**CHARTER TOWNSHIP OF VAN BUREN
PLANNING COMMISSION
July 13, 2022
MINUTES**

**Subject: VBT-22-006 Meijer / 9701 Belleville; Special Land Use Review #2
Revised Site Plans Dated June 15, 2022**

**Subject: VBT-22-006 Meijer / 9701 Belleville; Site Plan Review #3
Revised Site Plans Dated June 15, 2022**

Meijer Addition & Renovation Site Plan Final Site Plan and Engineering Review

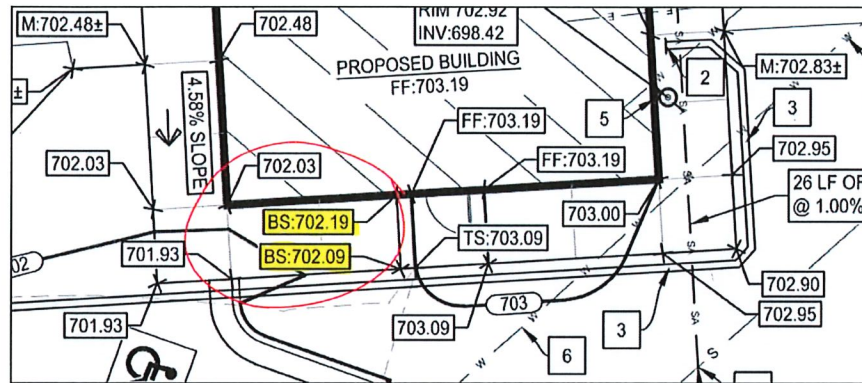
1. Applicant to verify the grades around the gas station building. Below shows a snippet where there is a 1.0 ft grade difference:

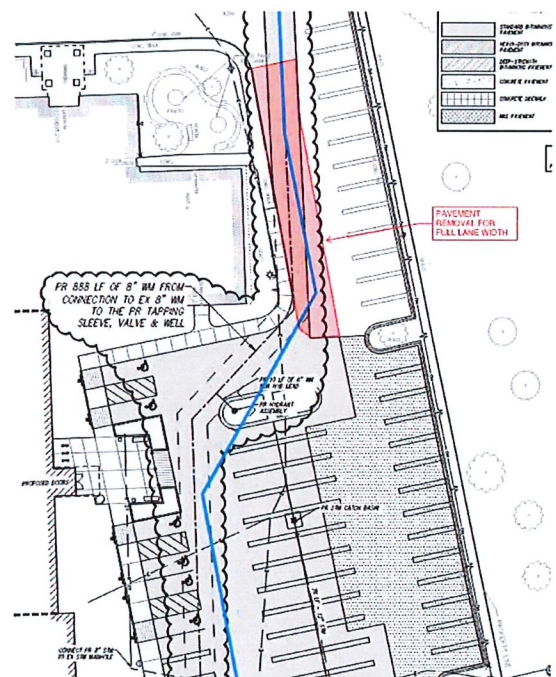
1. The new water main alignment has eliminated many of the unnecessary bends within the loop, however, has now created some alignments that may cause issues with future maintenance and lends to some awkward offsets and unfavorable pavement replacement. The previous straight-line alignment of the water main was acceptable (and desirable) however the excess bends were the problem. A hybrid of the two designs, similar to the blue line (drawing to the right) should be considered. The applicant shall explore a configuration that limits the number of required fittings and places the proposed water main locations are easily accessible for future repair and maintenance, which also limits the impact to pedestrian access (sidewalk repair).

2. Please also see the red outline for limits of pavement replacement to be sure no slivers of pavement remain. Uniform pavement repair/replacement shall be done when possible (See General Note No. 4).

Response: *Ongoing conversation with Fishbeck have occurred to provide a configuration that limits the number of required fittings and places the proposed watermain locations are easily accessible for future repair and maintenance, which also limits the impact to pedestrian access.*

Response: *Plans have been revised per limits of pavement replacement to be sure no slivers of pavement remain.*

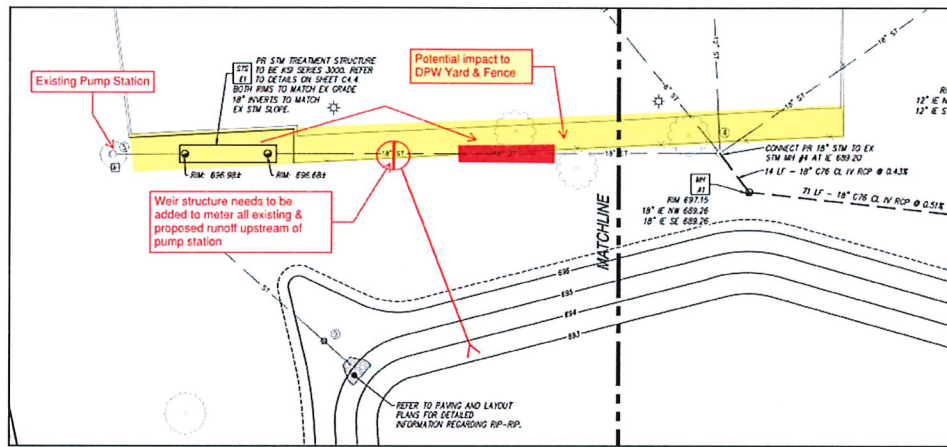
Township Discussion: Prior to submittal of the updated plans, the Township and the applicant have had several conversations about consolidating the overall stormwater management for both the proposed and existing system. Information on the existing pump station did not determine a metered value that could be used to determine if runoff was being detained the proper amount of time, thus it was determined that the entire contributing system would need to be accounted for and detained per Township Standards. The applicant would be responsible for detaining all flow upstream of the pump station for the required time, per the Township standards. The assumption was made that the existing swale/detention ponds between the soccer fields were functional and the flow from anything south of the splash pad would not be considered. Based on this criteria, the applicant has proposed a single, larger pond to accommodate all the incoming flow. The pond will be a dry pond, which is acceptable by the Township.
